Figure 3. Correct-Flange Nut Only

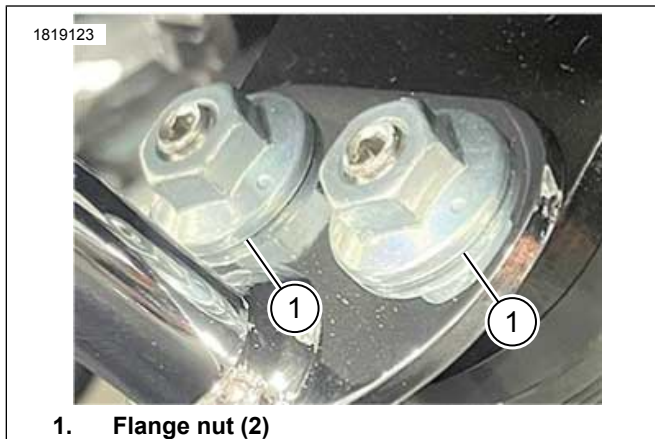
- Flange Nuts:** Confirmed, work complete. See Figure 3.
